**CLOSURE PLAN
REVIEW**

RE: Facility Closure Plan Review
Agua Moss, L.L.C. - Commercial Surface Waste Management Facility
Permit NM-1-009: Sunco Class I Injection Facility
Location: Section 2, Township 29 North, Range 12 West, NMPM
San Juan County, New Mexico

Review Comments
Agua Moss, L.L.C. - Sunco Class I Injection Facility
Commercial Surface Waste Management Facility
July 9, 2013

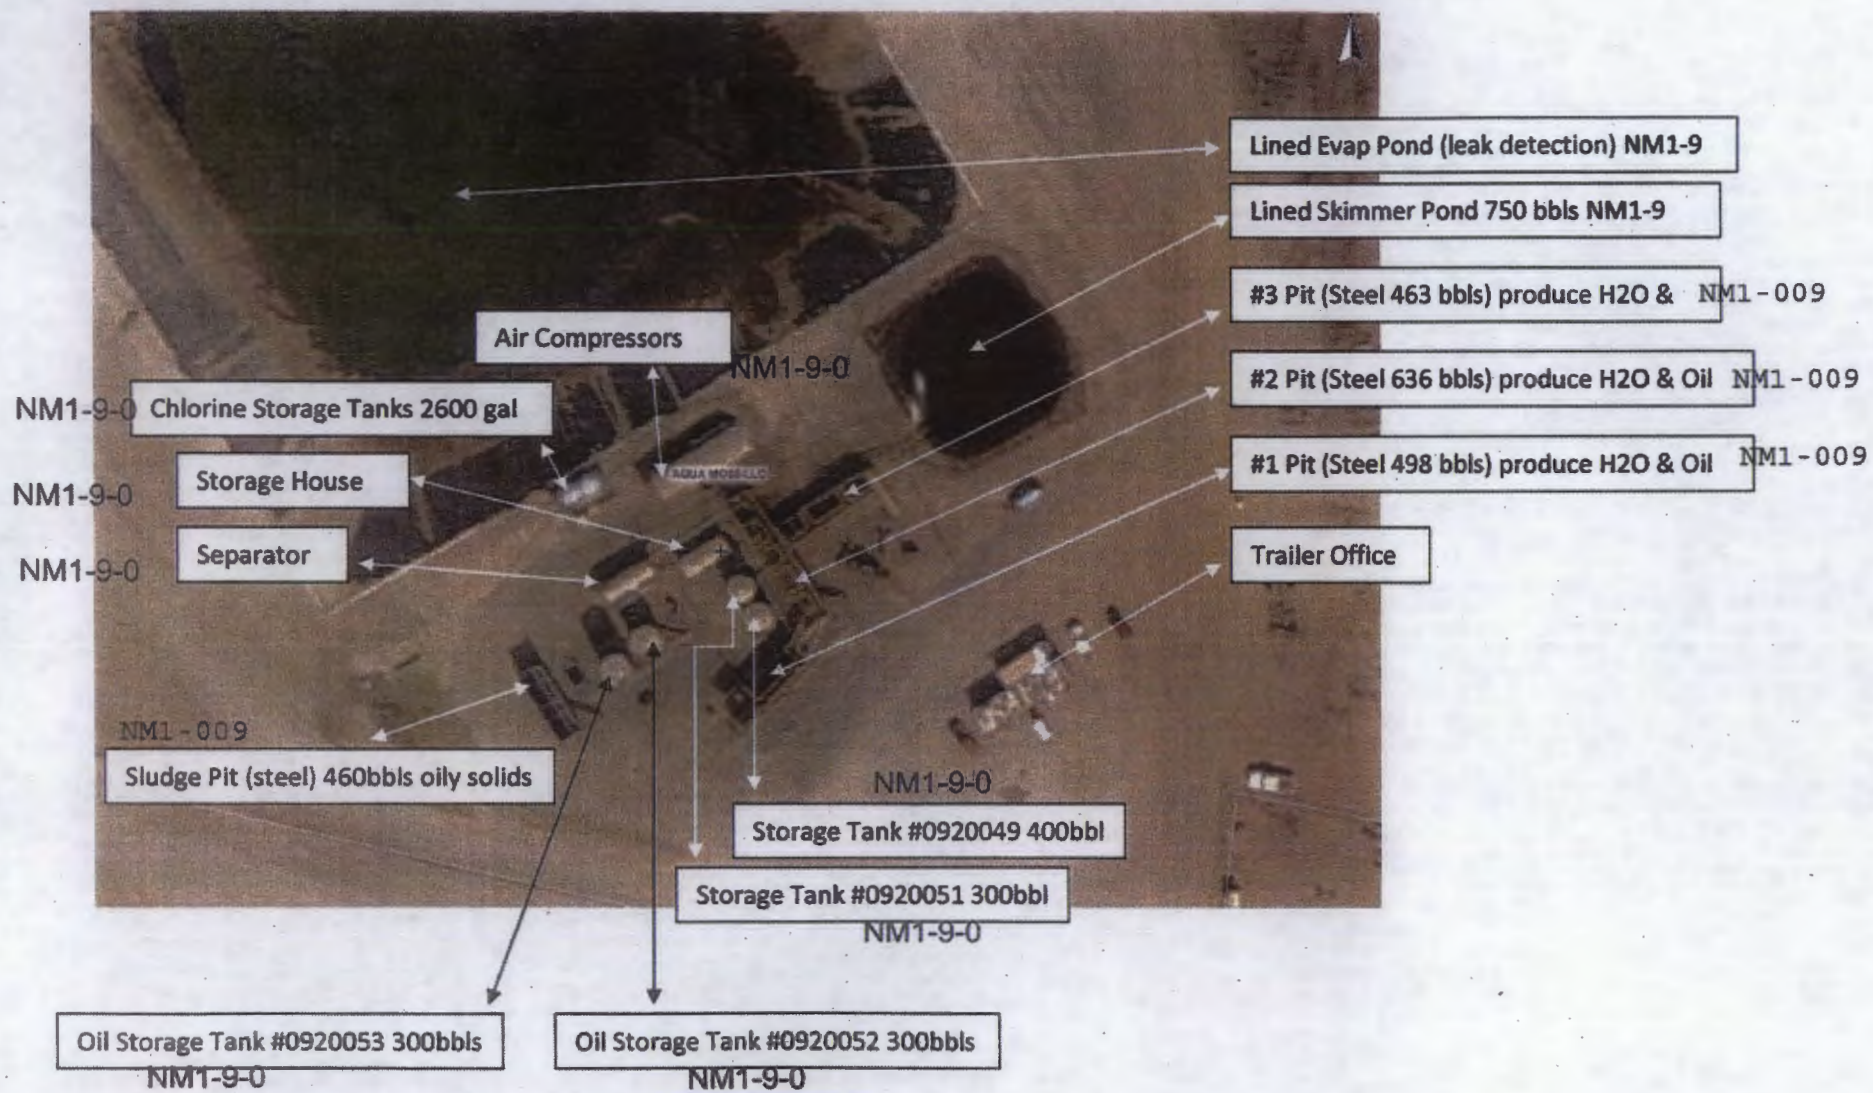
The response states that Agua Moss "will begin dirt work of the Un-loading facility and ponds as indicated in the Surface facility diagram." Please provide and/or reference the location of the "Surface facility diagram" that identifies the protocol for back-filling excavated areas (the ponds and stabilization units) and re-contouring the site.

Please provide a backfilling and re-contouring/grading plan.
